CITY OF ALBUQUERQUE

**RE: MDS - Montage Subdivision Unit 7 on Bobby Foster
Grading and Drainage Submittal for Preliminary Plat and Grading Permit
Engineer's Stamp Date: 6/30/22
Hydrology File: R16D100A**

**MONTAGE 7 SUBDIVISION AT MESA DEL SOL
DRAINAGE STUDY**

TITLE:
**BASIN MAP
MONTAGE 7 - MESA DEL SOL**

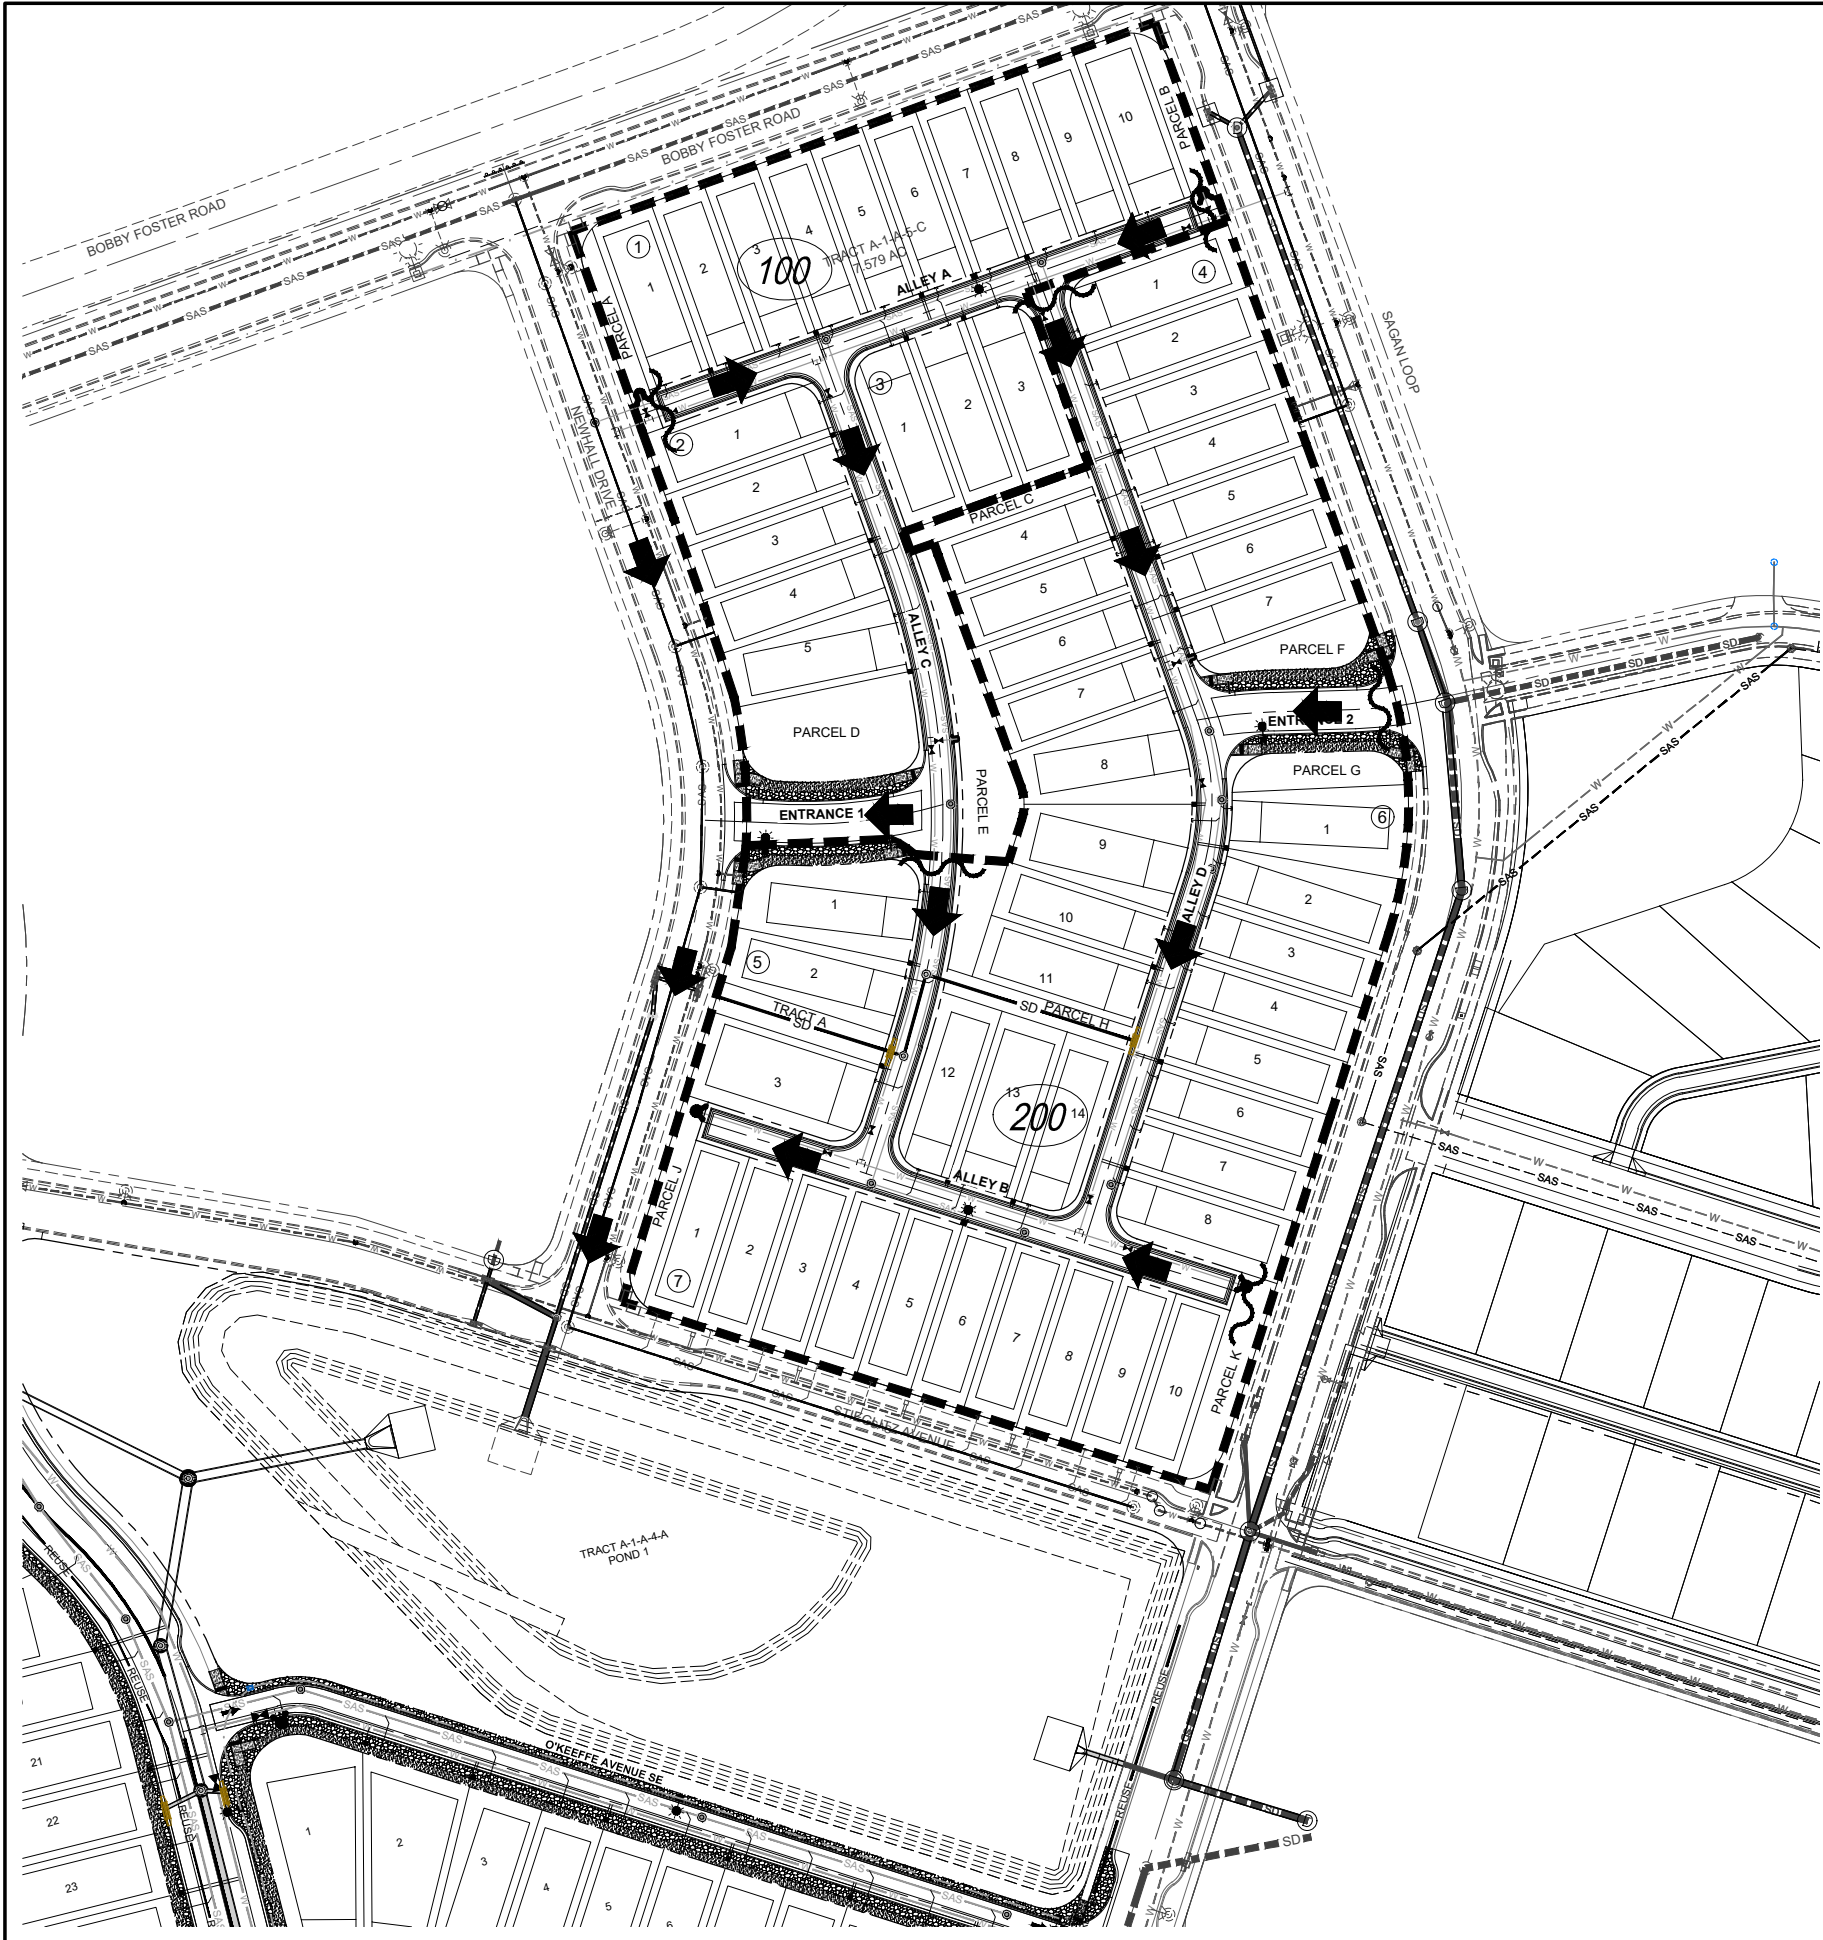
2. The only thing received was a Drainage Report that provided onsite hydrology analysis splitting the site into two large basins. More detailed sub-basin analysis will be required prior to approval of the Infrastructure List (IL) and Preliminary Plat (PP). Proration may be used instead of AHYMO models for each sub-basin.

5. The existing and proposed storm pipes and inlets with sizes and hydraulic analysis were missing from the basin map in the drainage report. The analysis is required prior to approval for this PP.
